RE: SITE MANAGEMENT PLAN – LOT 600 ON SP170062

SITE MANAGEMENT PLAN

RPD Lot 600 on SP 170062
County of Ward
Parish of Barrow

TITLE Former Cattle Dip Site, Maudsland	
RPD Lot 600 on SP170062	SITE ADDRESS Maudsland Road, Maudsland
DATE 07.02.07	SCALE 1:1000 @ A3
REFERENCE EMR 3581

TITLE Former Cattle Dip Site, Maudsland			
RPD	Lot 600 on SP170062	SITE ADDRESS	Maudsland Road, Maudsland
DATE	07.02.07	SCALE	1:1000 @ A3
REFERENCE	EMR 3581

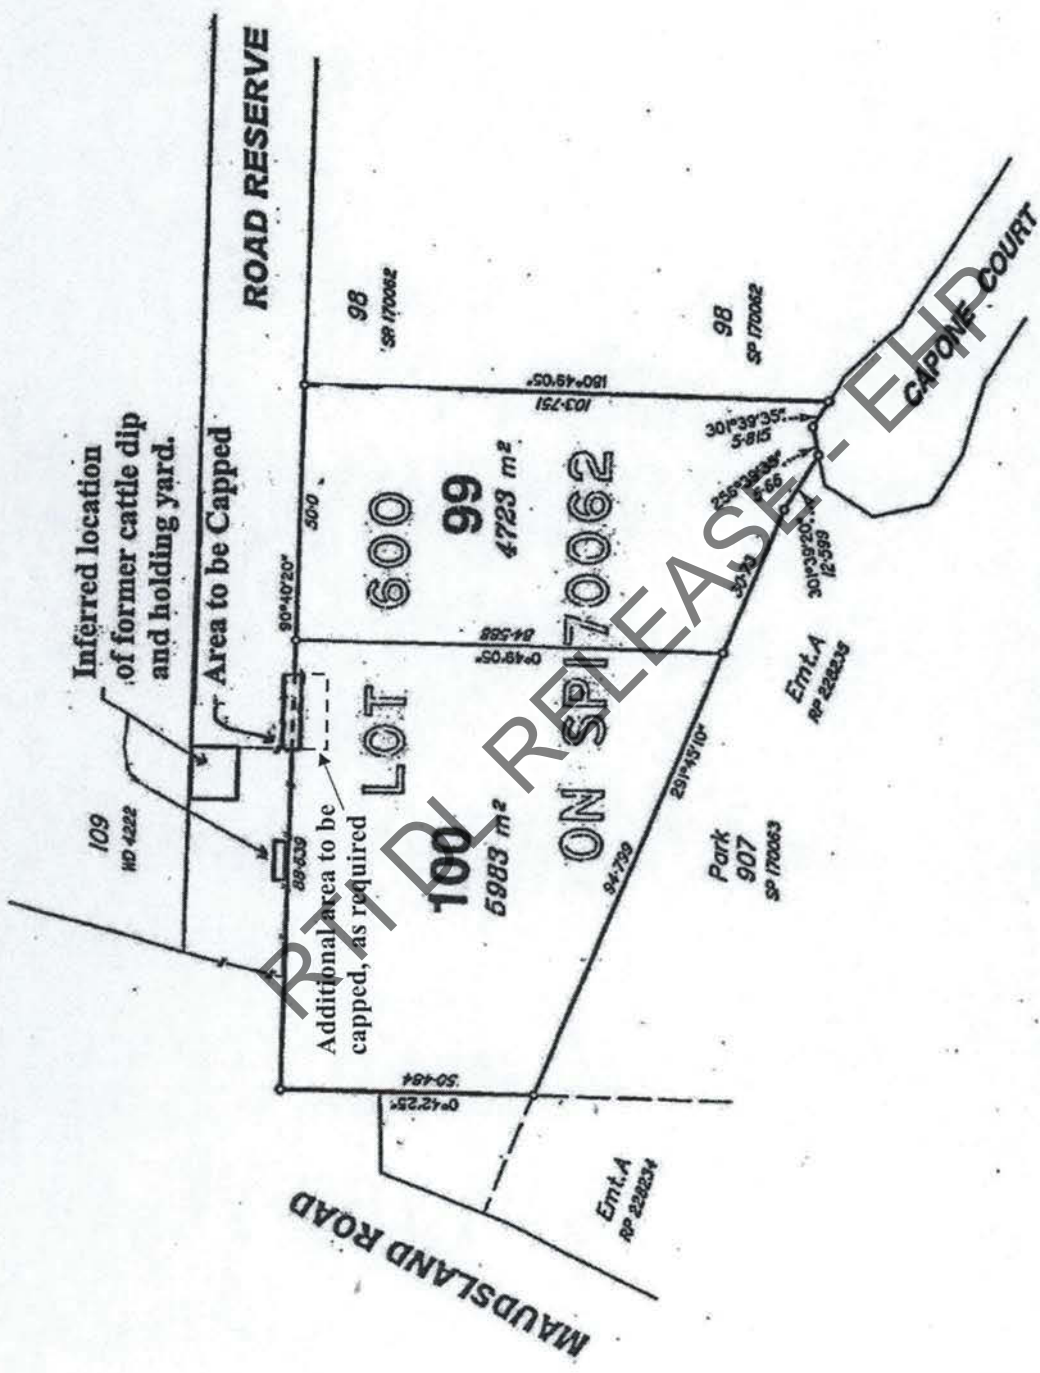
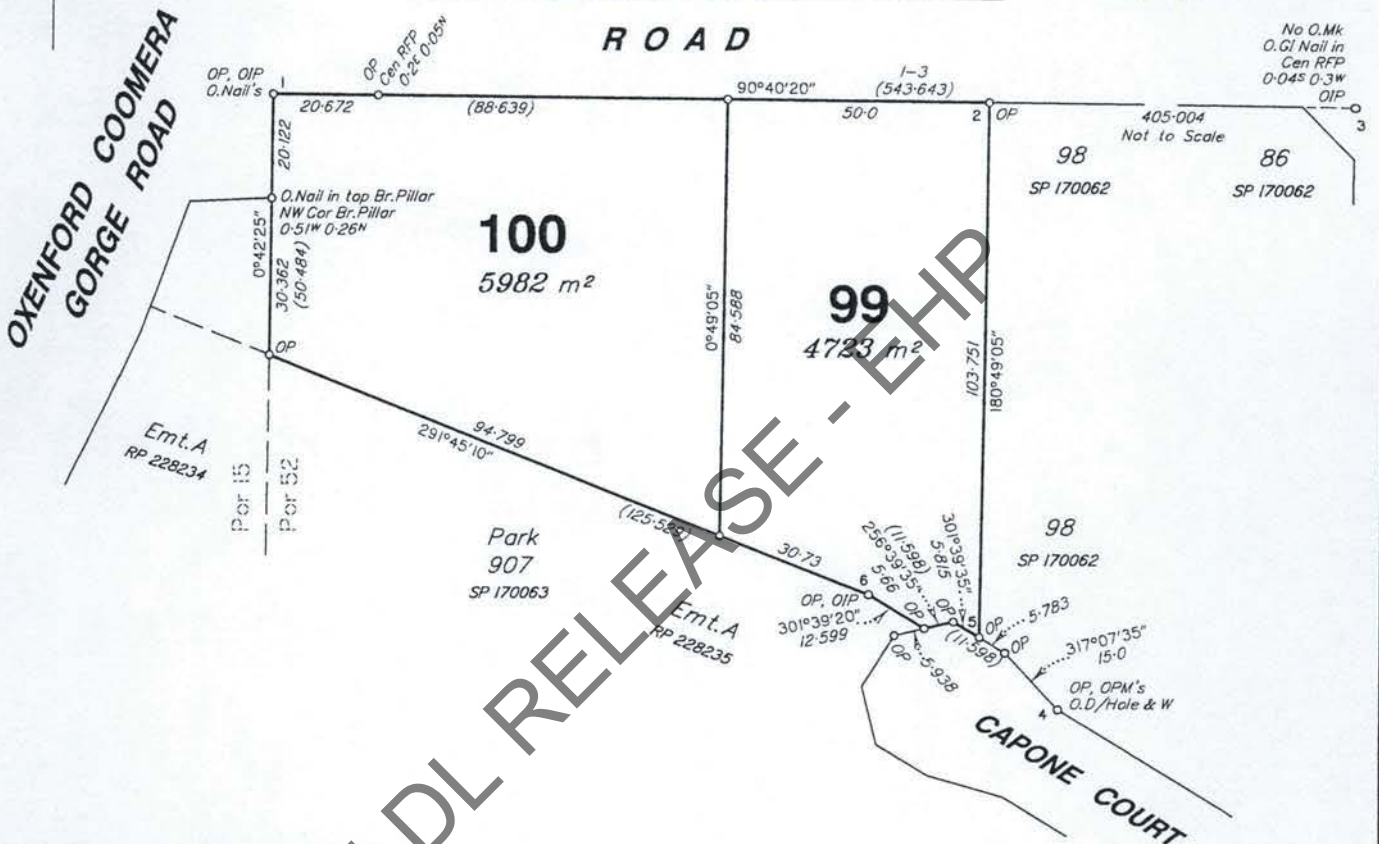
As I explained to you over the phone, the Suitability Statement for lot 600 on SP17230 (proposed lots 100 and 99) is about to be issued. However, the figure of the Site Management Plan and Remediation Action plan that actually shows the area to be capped has not been signed (the last sheet of documents sent by you). The Figure signed by Mr Steve Rothwell does not show such area.

Note:
This was replaced
by attached drawing
showing the area to
be capped. Sandra
03/01/07

I have attached the correct figure that requires his signature. Could you please arrange this and sent to me via email (scan) or Fax asap, and send us the original?
